Project	<b>IEEE 802.16 Broadband Wireless Access Working Group</b> < <a href="http://ieee802.org/16">http://ieee802.org/16</a> >	
Title	<b>Changes to IEEE 802.16h-06/004 relating to CMI Definition</b>	
Date Submitted	<b>2006-03-09</b>	
Source(s)	John Sydor Communications Research Centre  3701 Carling Avenue Ottawa, ON, Canada, K2H 8S2	Voice: 613-998-2388  <a href="mailto:john.sydor@crc.ca">john.sydor@crc.ca</a>
Re:	Outcomes from Session 42	
Abstract	This document contains changes in support of the decision to identify the CMI for same profile applications. Changes are to existing text and mostly editorial in nature.	
Purpose	To harmonize contributions with existing text.	
Notice	This document has been prepared to assist IEEE 802.16. It is offered as a basis for discussion and is not binding on the contributing individual(s) or organization(s). The material in this document is subject to change in form and content after further study. The contributor(s) reserve (s) the right to add, amend or withdraw material contained herein.

### **Changes to IEEE 802.16h-06/004 relating to CMI Definition**

**Overview: These are changes to existing text, with some clarifications. This is submitte

Figure h13 . ~~Alternative Timing of Coexistence Time Slot~~  
**CMI Timing (CTS should be changed to CMI)**

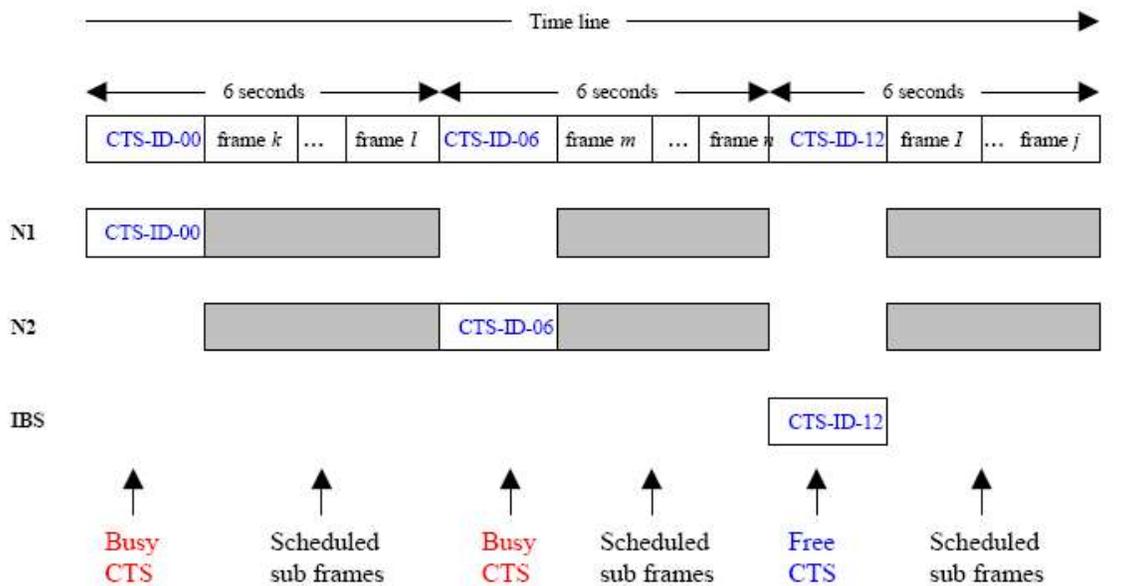
A ~~coexistence time slot (CTS)~~ **Coexistence Messaging Interval (CMI)** is a reserved physical frame used for the coexistence protocol signaling purposes. **The CMI is used with systems having the same profile (15.2.2.3.1) and synchronized MAC frames. The position of the CMI and the subsequent IEEE 802.16 MAC frames are synchronized to a GPS timing signal (15.7.2.1.1). Furthermore, the CMI are identified by UTC time stamps (15.7.2.1.1.3).** For example, the beginning of the first ~~CTS CMI~~ **CMI** is at HH:MM:00 UTC, the second ~~CTS CMI~~ **CMI** is at HH:MM:06 UTC, etc. The beginning of every ~~CTS slot~~ **CMI** is specified by a UTC message (time stamp) (Figure h 13).
